SECTION 00 91 13
ADDENDUM NO. 04

EUREKA CORRIDOR AND FRANK & POET DRAIN IMPROVEMENTS

DATE OF ISSUE: December 19, 2024
DATE OF ADVERTISEMENT: December 19, 2024
DATE OF BID OPENING February 25, 2025
PROJECT NO.: QuestCDN 9470865

**TYPICAL RETAINING WALL SECTION
CONCRETE FACED SHEET PILE WALL**
NO SCALE

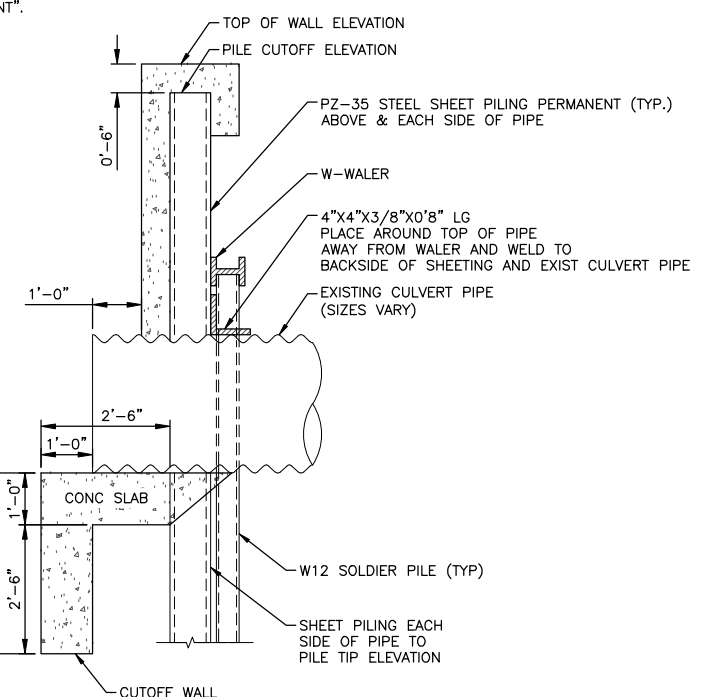
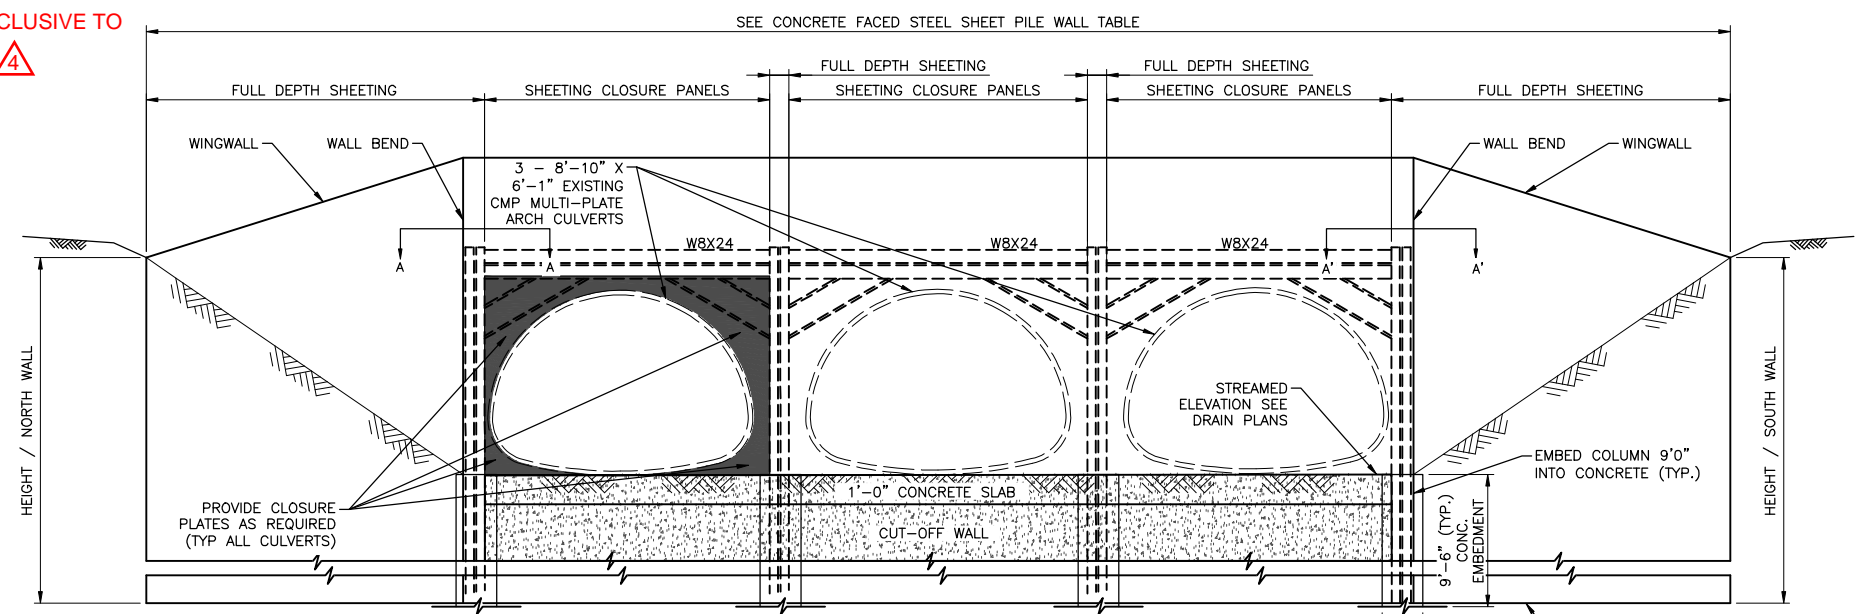
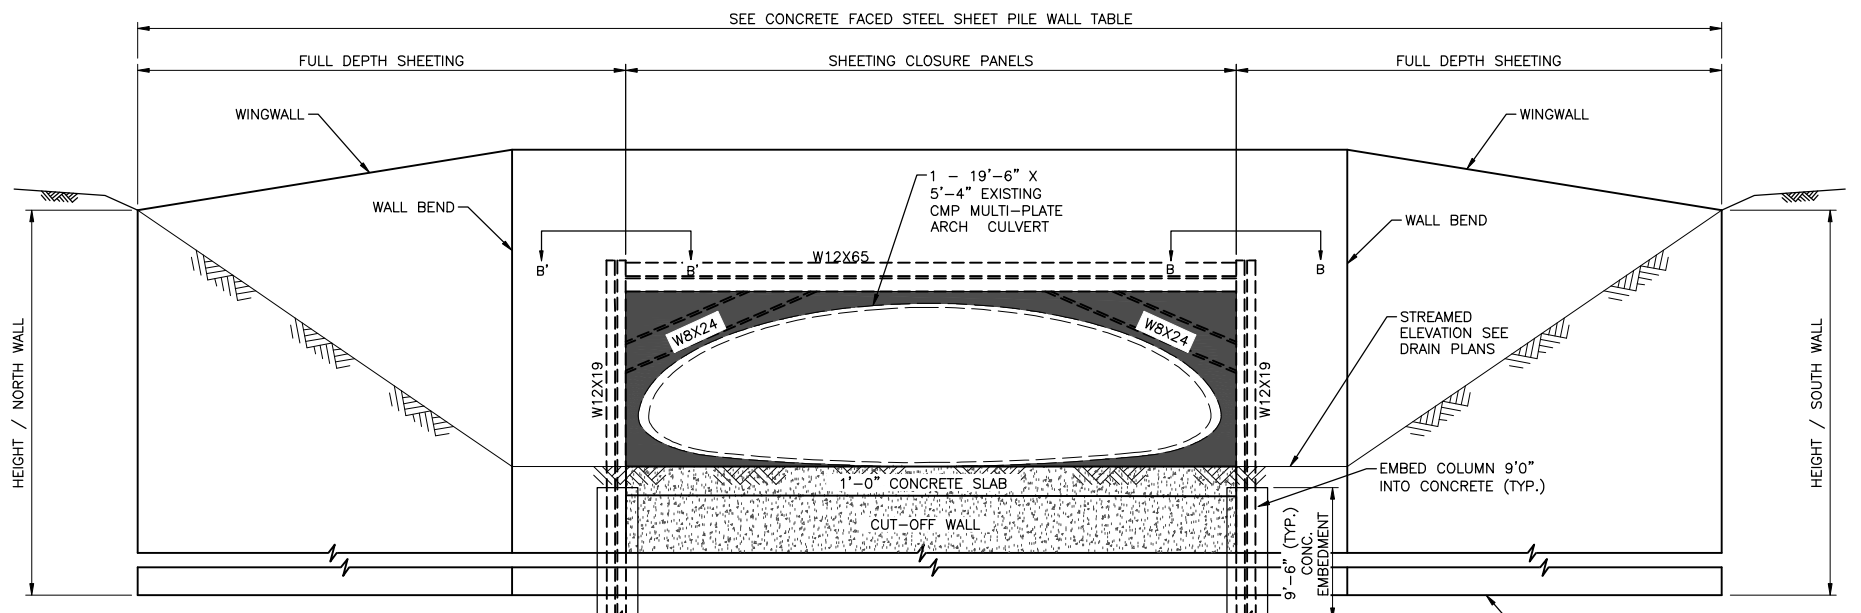
- A. Sheet C-5.06 - Concrete Faced Sheet Pile Wall Detail Sheet – “Typical Retaining Wall Section Concrete Faced Sheet Pile Wall” detail has been revised to clarify that payment for chain link fence will be inclusive to Items 63-67.

<p>27) There is a standard detail on Sheet C-5.06 that shows chain-link fence on top of a retaining wall. Is this detail applicable to any or all the headwalls? Is there anywhere else that this detail applies?</p>	<p><i>This detail is applicable to all headwalls and wingwalls. "Typical Retaining Wall Section Concrete Faced Sheet Pile Wall" detail has been revised to clarify that payment for chain link fence will be inclusive to Items 63-67.</i></p>
<p>28) There is a specification section for fencing that covers chain-link and woven wire fencing. The Proposal sheets only include "...Split rail fence" – item 17, and "Railing, Ameristar..." – items 39 and 40. There is no pay item for Chain-link fence. Please clarify if chain-link fence is required anywhere on this project.</p>	<p><i>Chain link fence is used only where mounted on top of concrete headwalls and wingwalls as shown in Typical Retaining Wall Section Concrete Faced Sheet Pile Wall" detail on sheet C-5.06. This fence will be paid for inclusive to Items 63-67 and so no separate item number exists.</i></p>
